FORM APPROVED
OMB NO. 1004-0137
Expires: January 31, 2018**SUNDRY NOTICES AND REPORTS ON WELLS**
*Do not use this form for proposals to drill or to re-enter an abandoned well. Use form 3160-3 (APD) for such proposals.*REC'D MIDLAND
JAN 06 2020

XTO Permian Operating, LLC requests permission to make the following changes to the original APD:

XTO Energy Inc.
Poker Lake Unit 27 Brushy Draw 104H
Projected TD: 26882' MD / 11130' TVD
SHL: 2510' FNL & 2043' FWL , Section 27, T25S, R30E
BHL: 2440' FNL & 2430' FWL , Section 10, T26S, R30E
Eddy County, NM

PECOS DISTRICT DRILLING CONDITIONS OF APPROVAL

13-3/8" x 9-5/8" x 5-1/2" 10M RSH-2 Wellhead
Assembly, With T-EBS-F Tubing Head

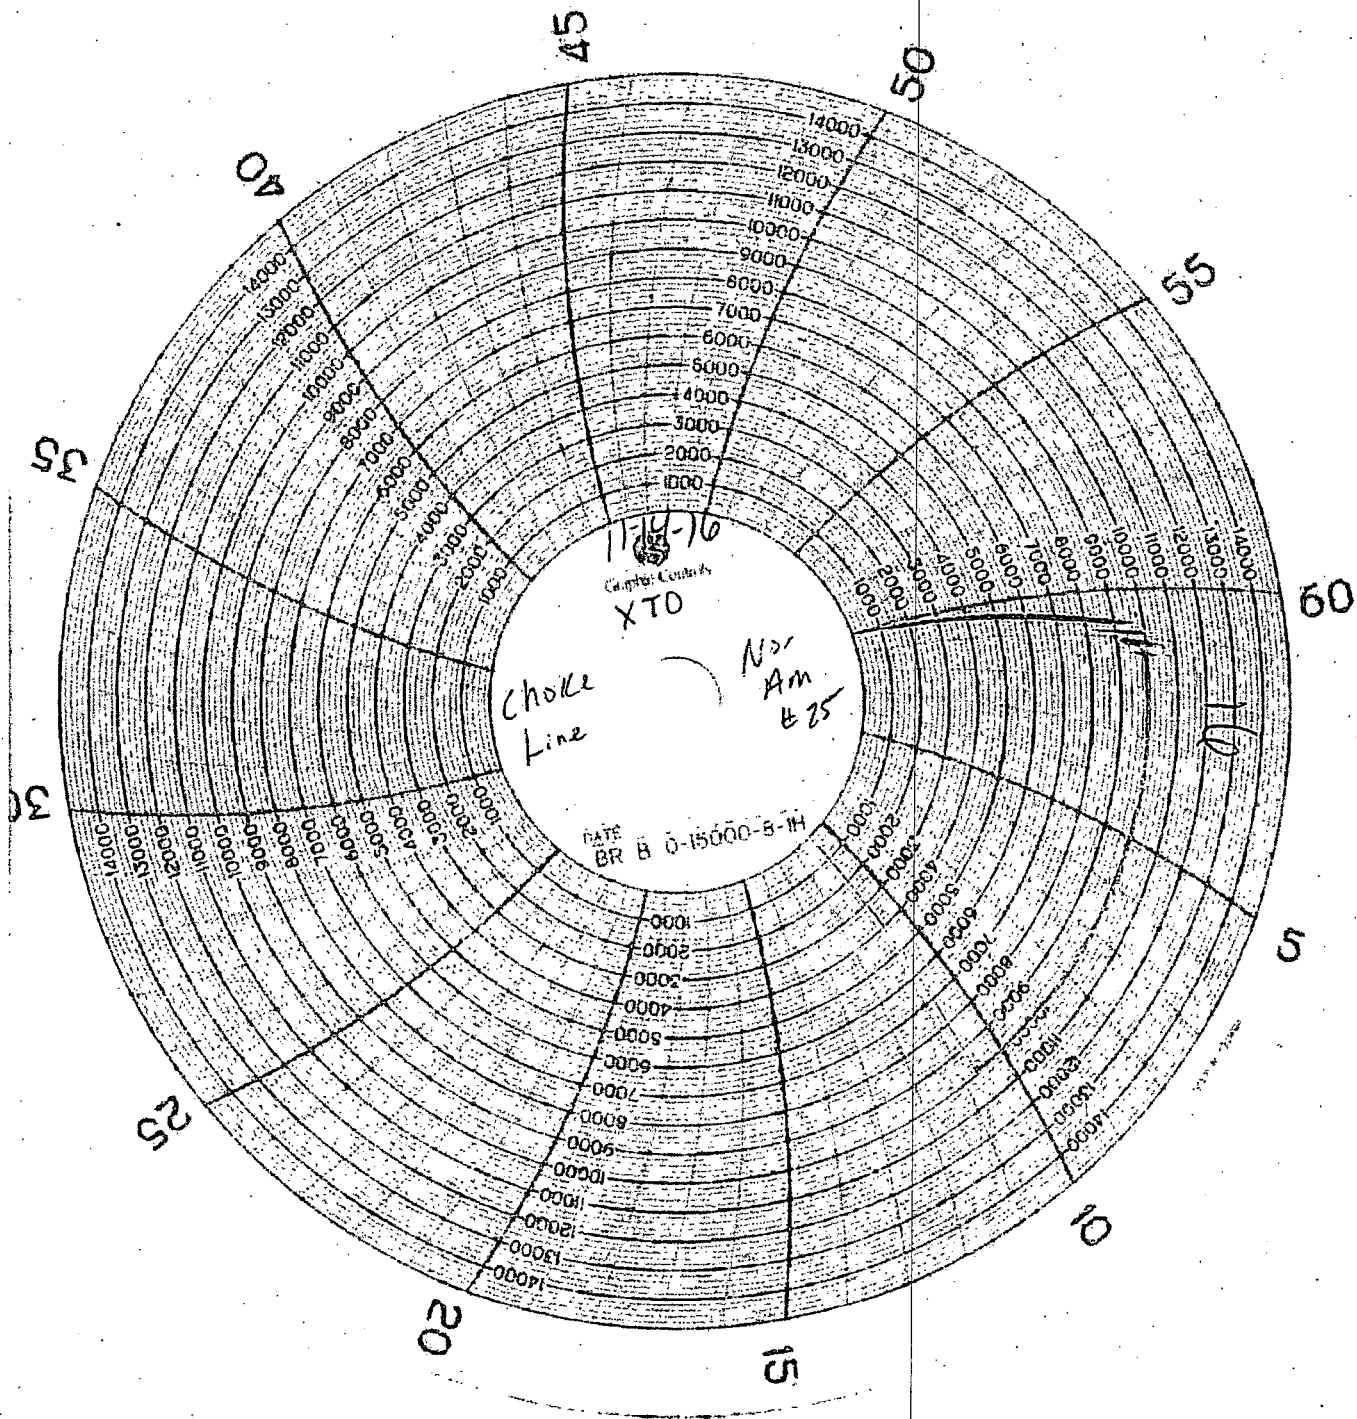
3. **Operator has proposed a multi-bowl wellhead assembly. This assembly will only be tested when installed on the surface casing. Minimum working pressure of the blowout preventer (BOP) and related equipment (BOPE) required for drilling below the surface casing shoe shall be 5000 (5M) psi.**

- a. **Wellhead shall be installed by manufacturer's representatives, submit documentation with subsequent sundry.**
 - b. **If the welding is performed by a third party, the manufacturer's representative shall monitor the temperature to verify that it does not exceed the maximum temperature of the seal.**

- c. **Manufacturer representative shall install the test plug for the initial BOP test.**
 - d. **Operator shall perform the intermediate casing integrity test to 70% of the casing burst. This will test the multi-bowl seals.**

- e. **If the cement does not circulate and one inch operations would have been possible with a standard wellhead, the well head shall be cut off, cementing operations performed and another wellhead installed.**

HOSE I.D. 2 1/2" LENGTH 424' END 1 4 1/16" 5/8" PL END 2 4 1/16" 5/8" PL
GRADE D WORKING PRESSURE 5,000 P.S.I.
TEST PRESSURE 7,500 P.S.I. ASSEMBLY DATE 6-8-14
TEST DATE 6-8-14 SERIAL # 633096011513D-060814-18400
NAME D. J. T. S. CR # 25673

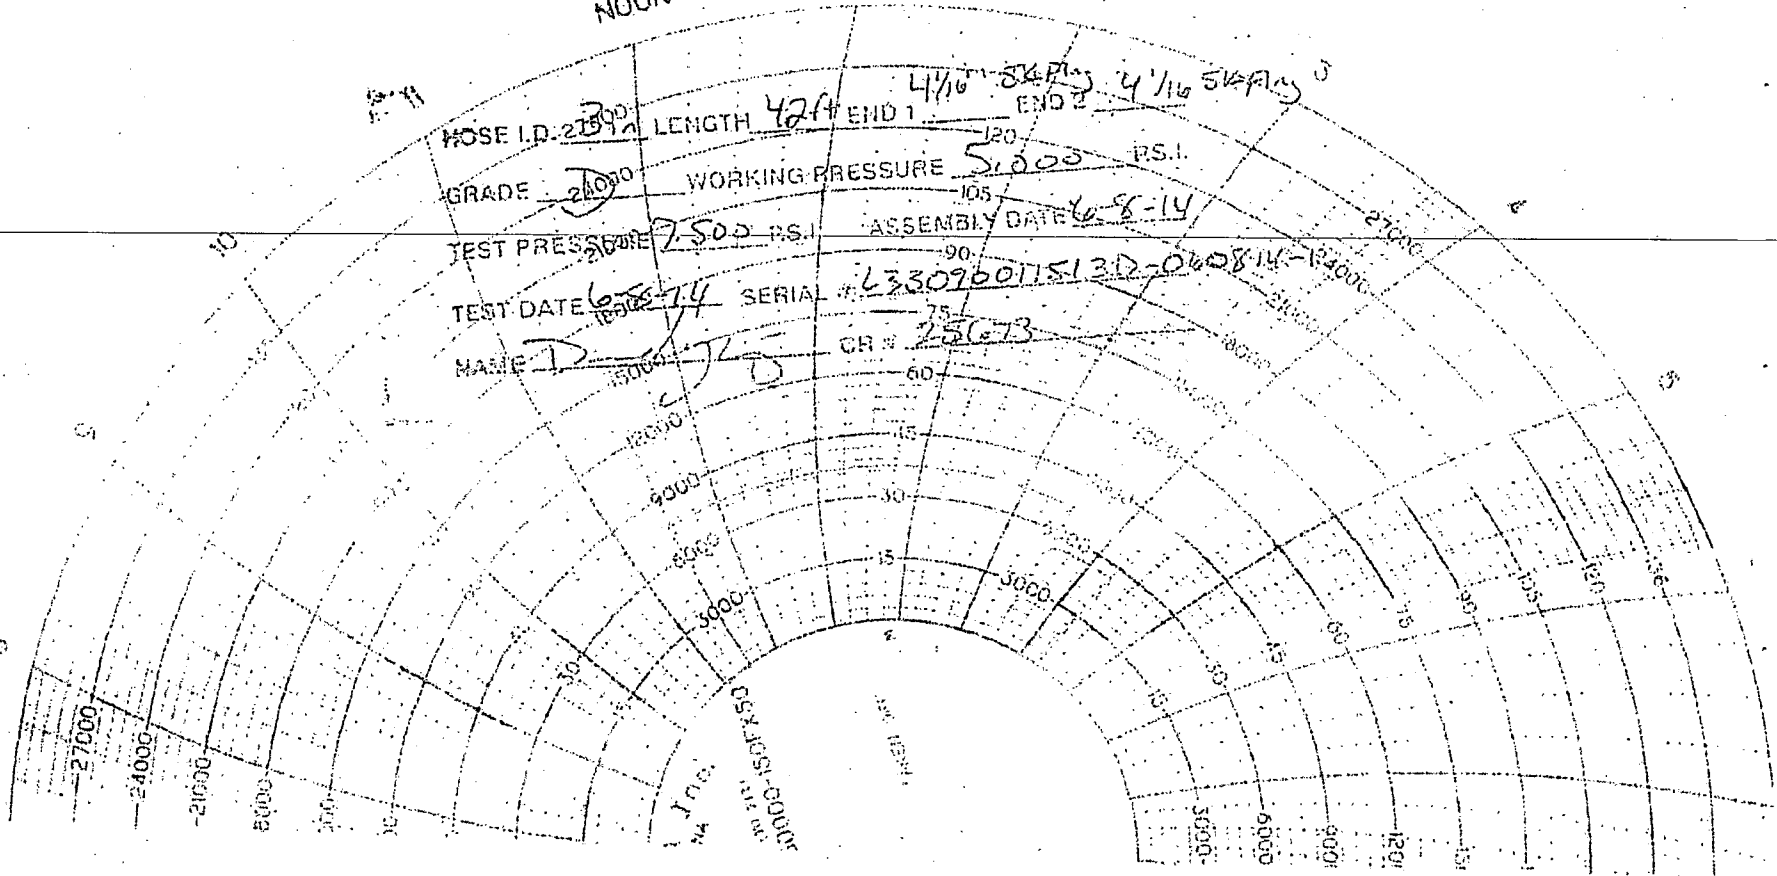
2. Variance approved to use flex line from BOP to choke manifold. Check condition of flexible line from BOP to choke manifold, replace if exterior is damaged or if line fails test. Line to be as straight as possible with no hard bends and is to be anchored according to Manufacturer's requirements. The flexible hose can be exchanged with a hose of equal size and equal or greater pressure rating. **Anchor requirements, specification sheet and hydrostatic pressure test certification matching the hose in service, to be onsite for review. These documents shall be posted in the company man's trailer and on the rig floor.** If the BLM inspector questions the straightness of the hose, a BLM engineer will be contacted and will review in the field or via picture supplied by inspector to determine if changes are required (operator shall expect delays if this occurs).
